Technical Service Information

THM 4L60 (700-R4) NEW DESIGN LUBE SEAL AND OUTPUT SHAFT

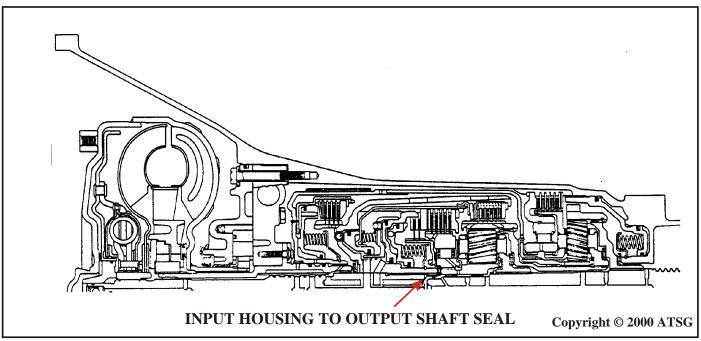
CHANGE: New design input housing to output shaft seal and revised lube hole location in output shaft.

REASON: Increased lube oil flow to Input Housing/Input Sun Gear Bearing. (See Figure 1).

(1) INPUT HOUSING LUBE SEAL - Now made of a soft rubber material instead of the previous hard plastic, is Red Oxide in color, and helps retain lube oil even in mis-alignment conditions because of soft material (See Figures 1 and 2).

(2) OUTPUT SHAFT - Revised lube hole location. New design can be identified by lube hole in the chamfer at the front of the output shaft. The previous design has the lube hole located on the pilot at the front of the output shaft (See Figure 2). The new design output shaft now aims lube oil directly at the Input Housing/Input Sun Gear Bearing for greatly increased durability (See Figure 1).

- (1) THE NEW DESIGN SEAL (SOFT RUBBER) "WILL NOT WORK WITH THE PREVIOUS DESIGN OUTPUT SHAFT. The lube hole in the pilot of the output shaft will tear the new style seal, and/or block the hole completely.
- (2) The previous design seal (Hard Plastic) "WILL" work with "ALL" shafts including the new design output shaft.
- (3) The new design output shaft and seal will retro fit back to any THM 700-R4 transmission ever built.
